# UNITED STATES PATENT AND TRADEMARK OFFICE

APPLICATION NO.	FILING DATE	FIRST NAMED INVENTOR	ATTORNEY DOCKET NO.	CONFIRMATION NO.
10/516,659	12/01/2004	Hermann Baumann	P/4674-2	8761

## Office Action Summary

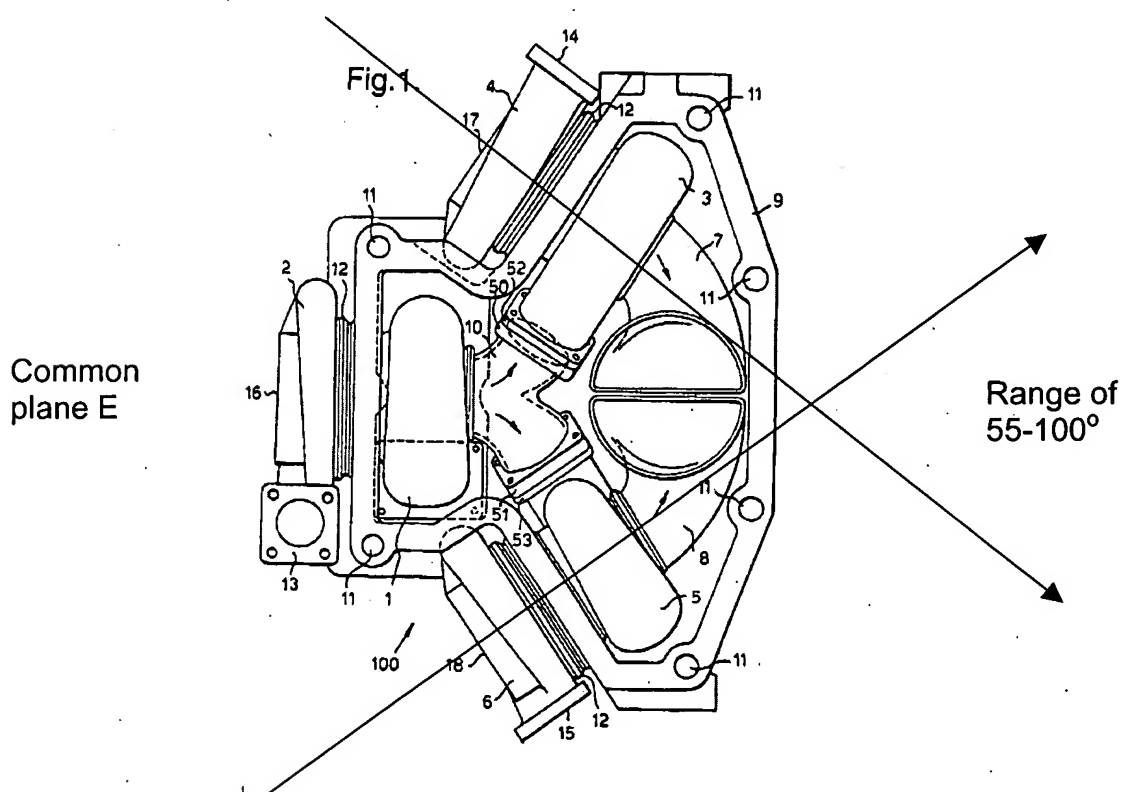
Ramsden discloses an internal combustion engine with a first and a second exhaust gas turbocharger (3, 4; 5, 6) for charging the internal combustion engine, each of the exhaust gas turbochargers comprises a compressor wheel and a turbine wheel, which rotate around a common charger axis (Not Numbered), a first exhaust gas feed line arranged to lead to the first exhaust gas turbocharger, a second exhaust gas feed line arranged to lead to the second exhaust gas turbocharger, the two exhaust gas turbochargers (3, 4; 5, 6) having parallel air flows, a carrier housing (9) arranged to hold the two exhaust gas turbochargers, a manifold arranged to collect exhaust gas streams downstream of the two exhaust gas turbochargers (3, 4; 5, 6), and a common exhaust gas discharge line (10) connected to the turbochargers (3, 4; 5, 6), the two exhaust gas turbochargers (3, 4; 5, 6) being arranged so that the two charger axes are at an angle to each other in a range of 55-100° and lie in a common plane (E) (See Figures 1, 3, and 4);

wherein the plane is parallel to a top of the internal combustion engine  
(See Figure 4);

wherein the exhaust gas discharge line is arranged to lie in the plane  
(See Figure 4);
